WATER PERMIT NO. 2259-2

Application For Permit To Appropriate Water Within The State Of South Dakota

PES Review
Rose Dam
Water Permit Application #2259-2

RE: Rose Ranch Impoundment Risk Assessment

TYPICAL CROSS SECTION OF DAM

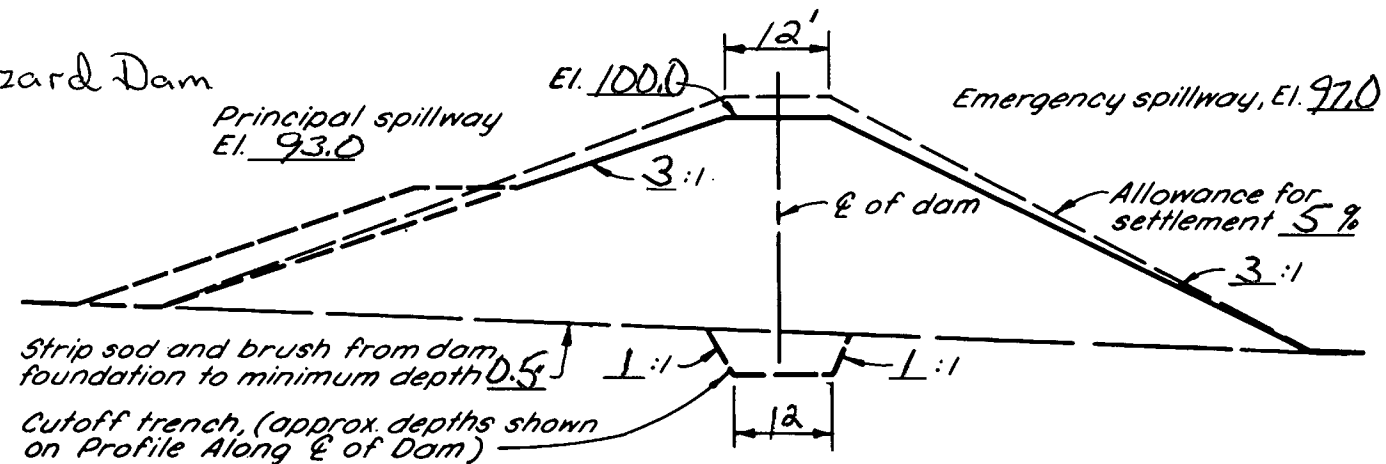
Top of Dam = 100 - 116.5 Ac.-Ft.
P. Spway = 93 - 37 Ac.-Ft.
Znd. Spway = 97 - 67 Ac.-Ft.
O/S Toe = 81

Dam Height = 19 ft.
Class A (Cat. 3) Dam
